**EXHIBITION OF ENVIRONMENTAL ASSESSMENT FOR CONCEPT PLAN AND
STAGE 1 PROJECT APPLICATION, MEADOWBANK EMPLOYMENT AREA,
MEADOWBANK AND RYDE
(MP09_0216 AND MP09_0219)**

SHEPHERDS BAY URBAN RENEWAL CONCEPT PROPOSAL, MEADOWBANK

Re: Concept Plan (MP09_0216) & Stage 1 Project Application (MP09_0219) – Exhibition of Environmental Assessment for residential development, ancillary commercial and retail uses and associated infrastructure, Meadowbank Employment Area, Meadowbank and Ryde

Re: MP 09_0216 and MP 09_0219 Concept Plan and Stage 1 Project Application for a Mixed Use Residential, Commercial, and Retail Development at Meadowbank and Ryde.

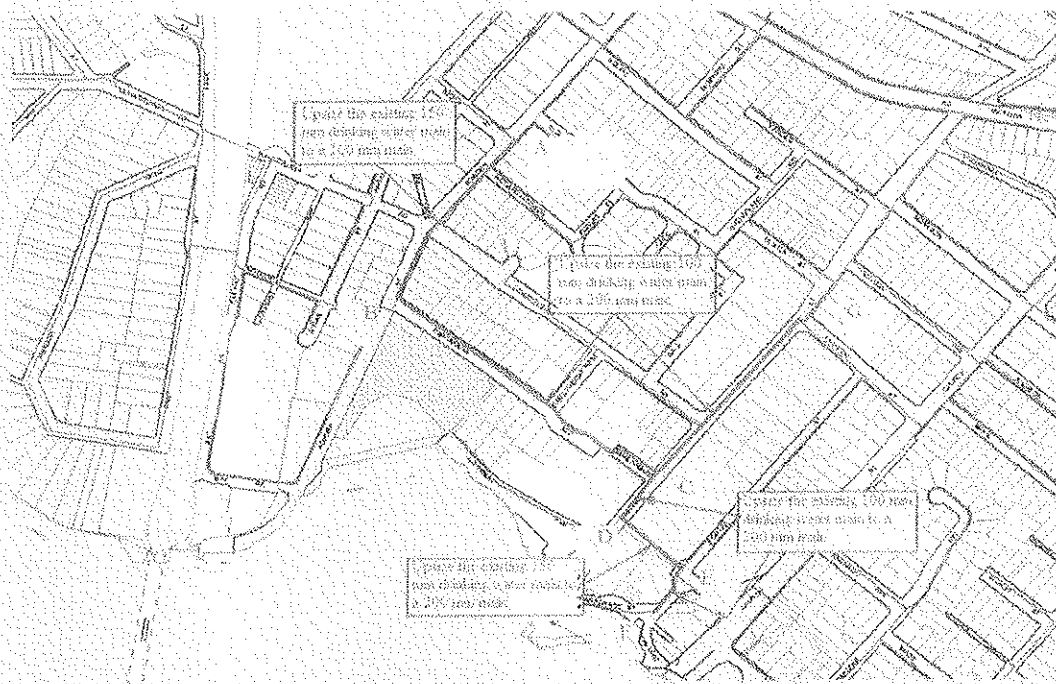
The current water system does not have sufficient capacity to service the proposed development. The drinking water mains fronting the proposed development do not comply with the minimum size required by the Water Supply Code of Australia (Sydney Water Edition – WSA 03-2002) to serve the capacity of the proposed development.

The following amplification works need to be completed by the developer to service the site, and can be seen on the diagram below:

- The existing 150 mm drinking water mains from A to B & from D to E need to be upsized to 200 mm mains.
- The existing 100 mm drinking water mains from B to C, C to D, C to G & from E to F need to be upsized to 200 mm mains.

The amplifications will need to be sized and configured according to the Water Supply Code of Australia (Sydney Water Edition WSA 03-2002). Evidence of Code compliance should be attached with the extension design.

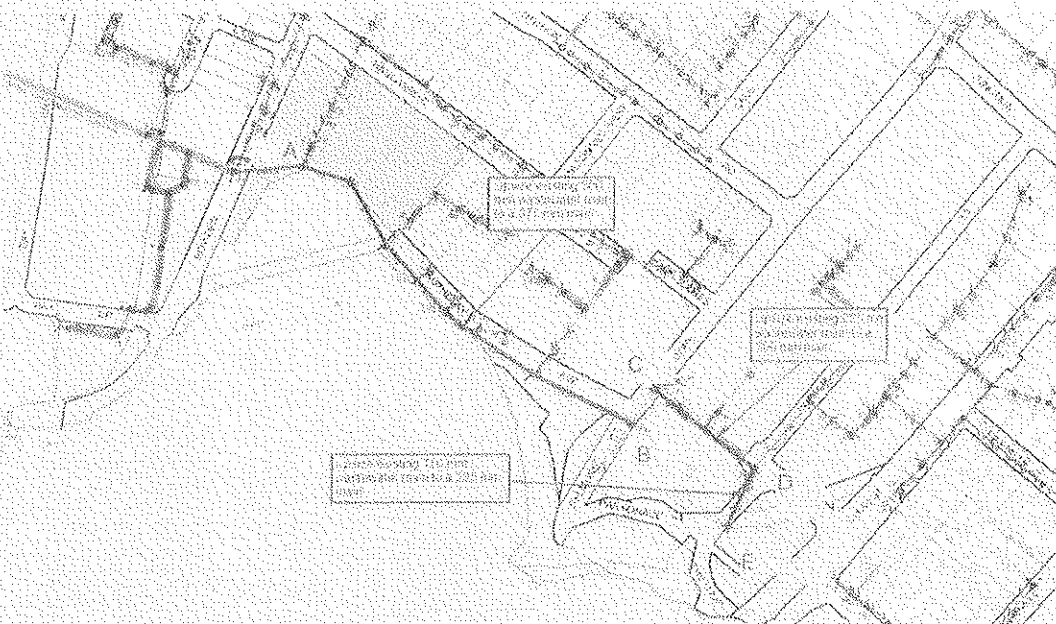
The current wastewater system does not have sufficient capacity to serve the proposed development. The following amplification works need to be completed by the developer to service the site, and can be seen on the diagram below:

- The existing 300 mm wastewater mains from A to B need to be upsized to 375 mm mains.
- The existing 225 mm wastewater mains from C to D need to be upsized to 300 mm mains.
- The existing 150 mm wastewater mains from D to E need to be upsized to 225 mm mains.
- All other wastewater mains located inside the development need to be upsized to either 225 mm mains & 300 mm mains.
- SPS 105 requires an increase in storage and an upgrade to cater for the extra flow.

The amplifications will need to be sized and configured according to the Water Supply Code of Australia (Sydney Water Edition WSA 03-2002). Evidence of Code compliance should be attached with the extension design.
